Office Action Summary	Application No. 10/523,096	Applicant(s) LEVINE ET AL.	
	Examiner Henry M. Johnson, III	Art Unit 3739

DETAILED ACTION

FIG. 2

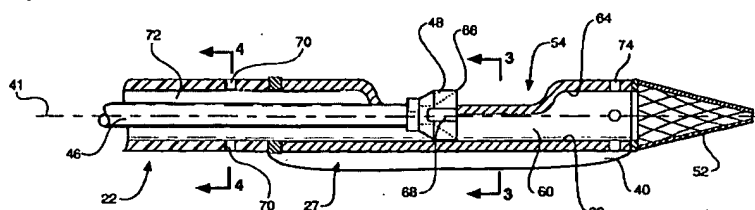
Claims 1 and 2 are rejected under 35 U.S.C. 102(b) as being anticipated by U.S. Patent 5,507,795 to Chiang et al. Chiang et al. disclose a catheter with a catheter body (Fig. 2, # 22)

and a cutting blade (Fig. 2, # 48). The catheter includes a cutter housing aperture (opening) for the cutting blade (Col. 7, lines 45-51). The

cutting blade is clearly capable of cutting a chord attaching an atrioventricular leaflet. The item actually cut is intended use.
